# ILC Interaction Region Configuration Change Request

LCWS14, Belgrade  
Karsten Buesser  
07.10.2014

## **DETECTOR HALL WITH VERTICAL SHAFT ACCESS**

# Hybrid-A' General layout

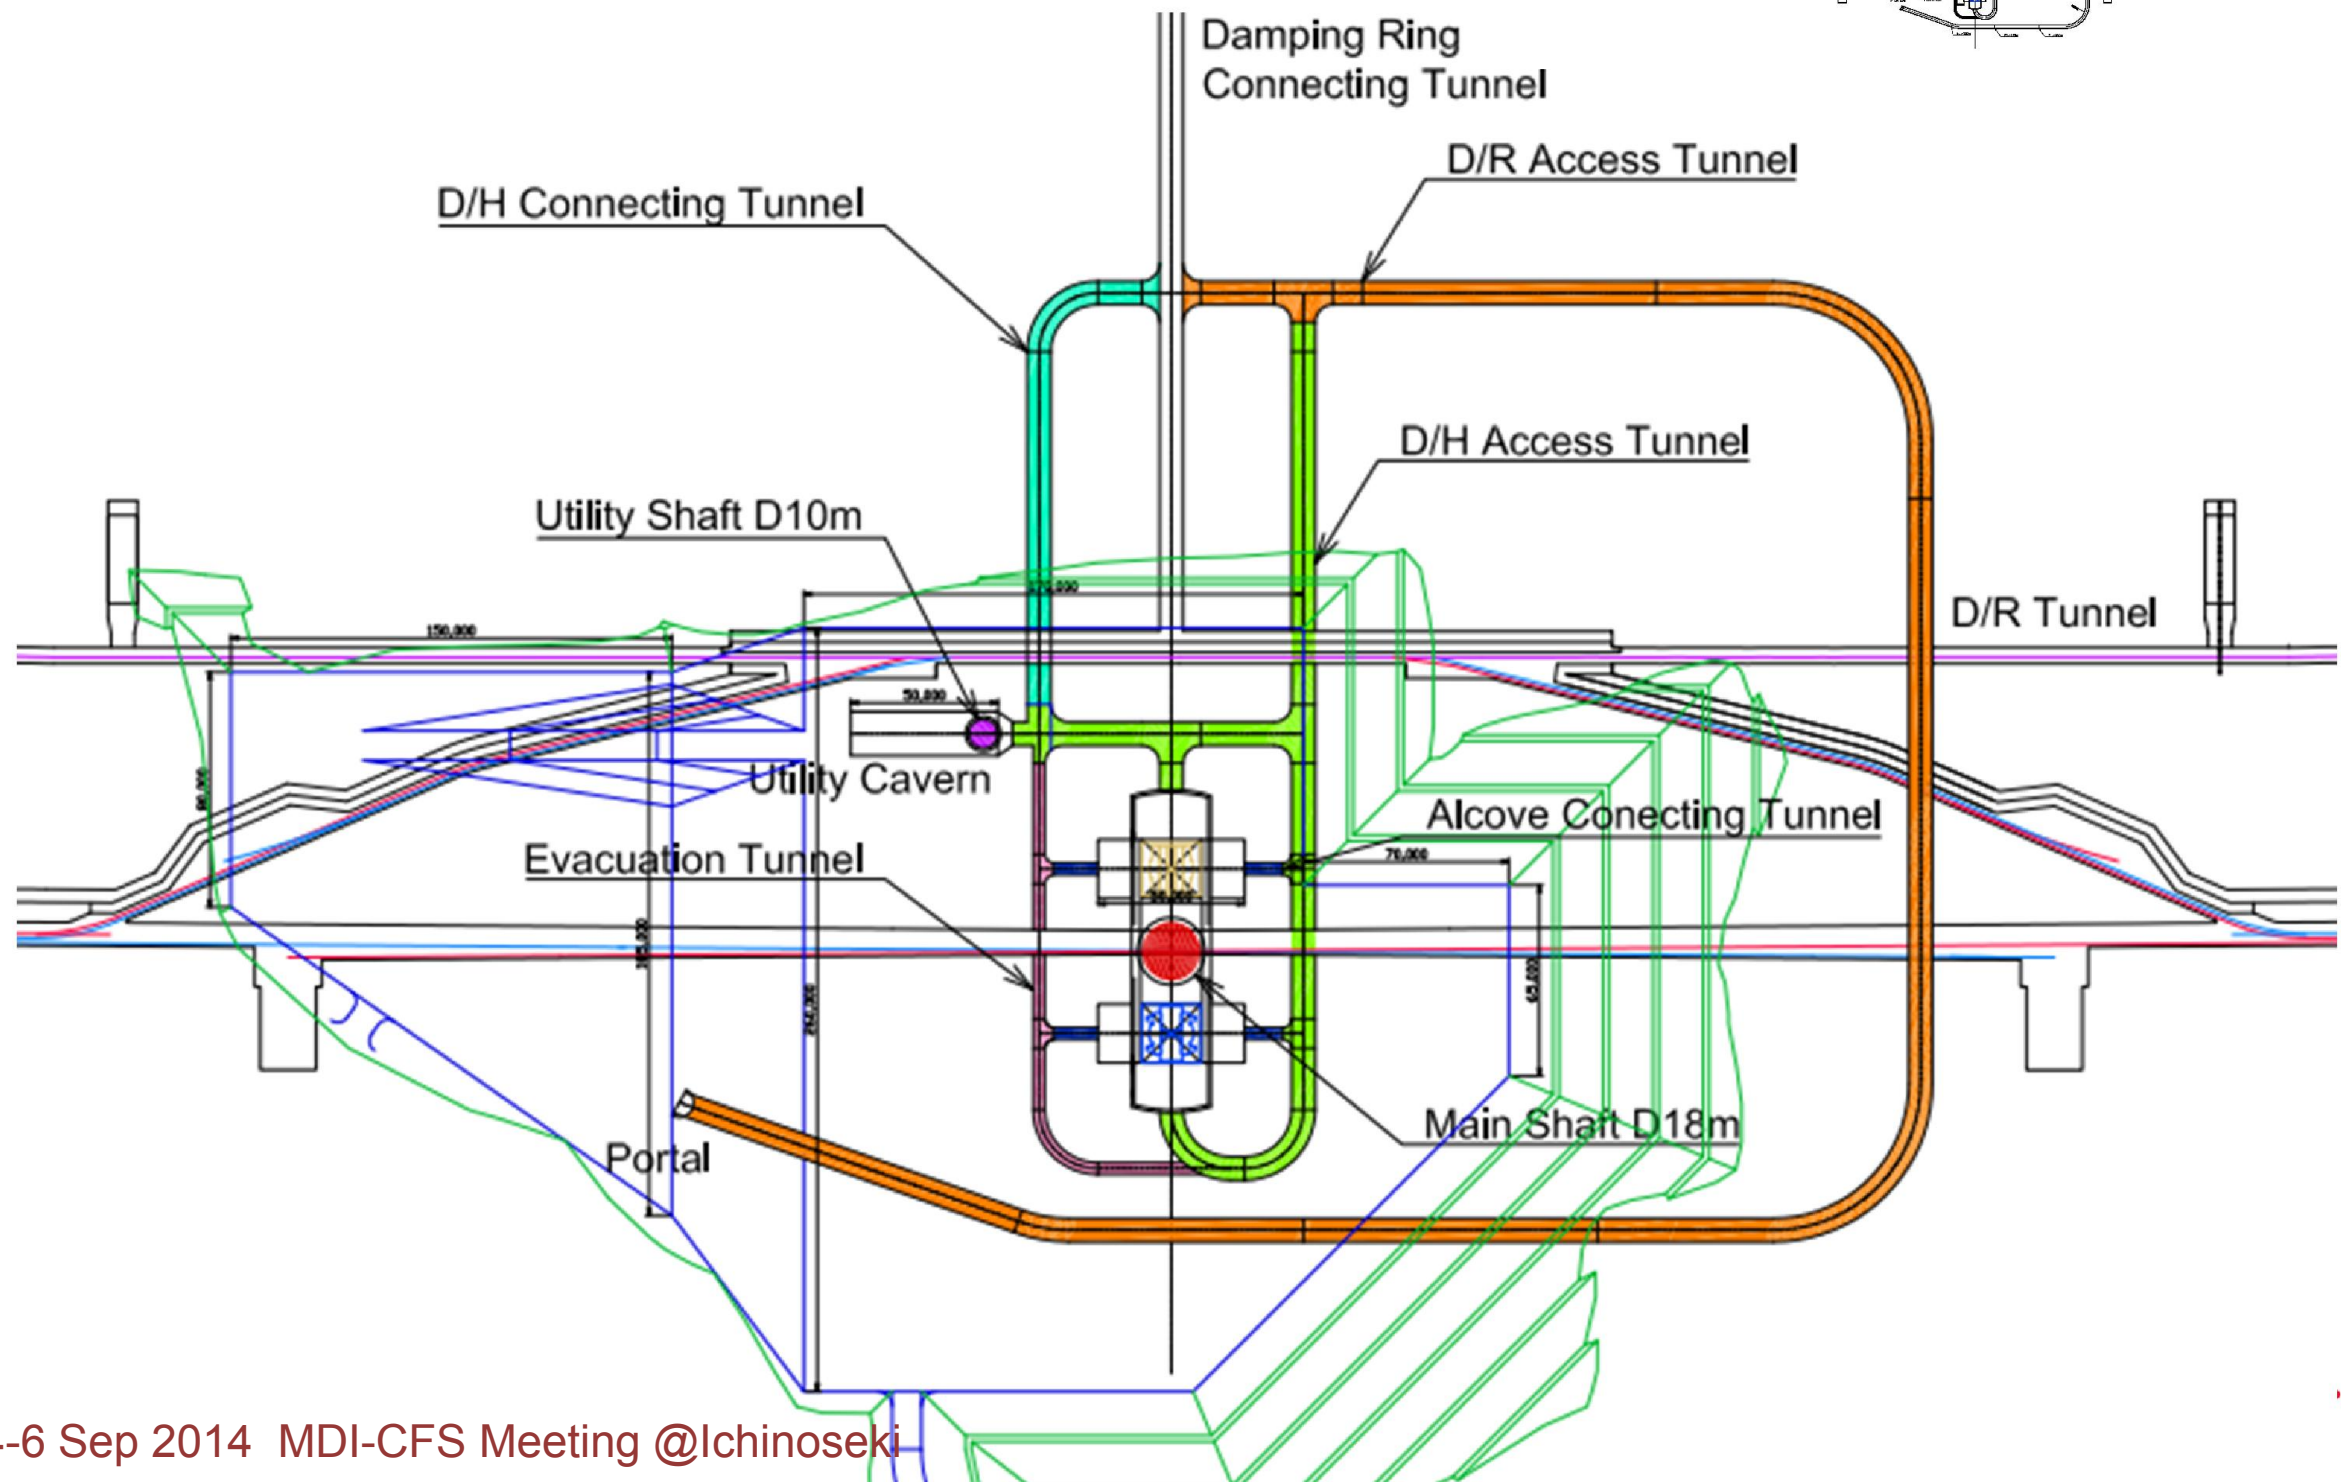
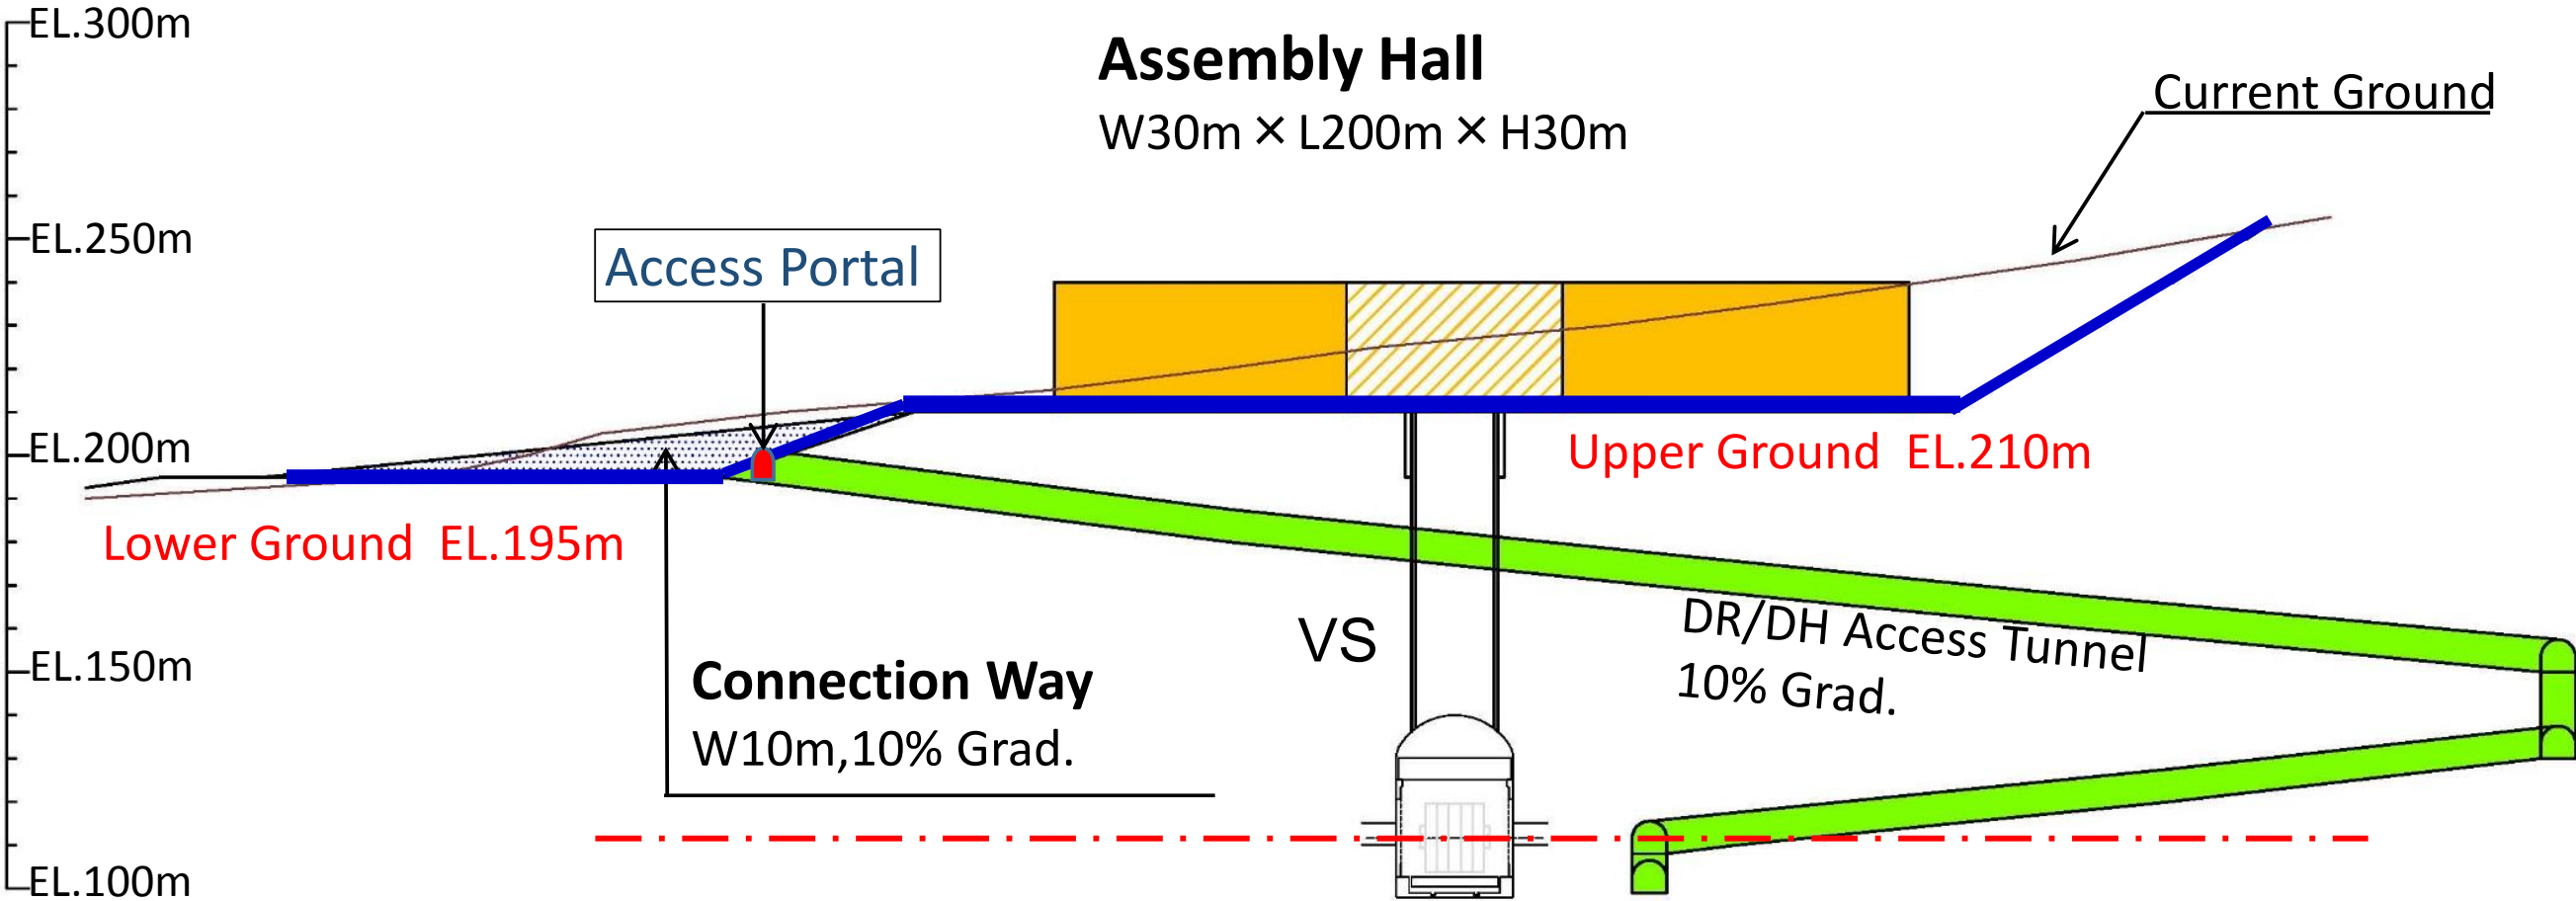
Change the underground experimental hall to a design that has a large vertical shaft and allows for the “CMS style” assembly of the detectors.

- In very collaborative efforts we have found an optimised IR design for the Kitakami site
- Detectors assembled mostly on surface
  - especially the magnet systems - solenoids, yokes
- Underground area with
  - one central detector assembly shaft (18m)
  - service shaft for detectors and machine (10m)
  - horizontal tunnel (8m) for damping ring and detector hall access
- Agreement between all involved: MDI, CFS, ILD, SiD, ILC...
- Submission of change request document is first step in change control process
  - more detailed information will be provided on request by the Change Management Board
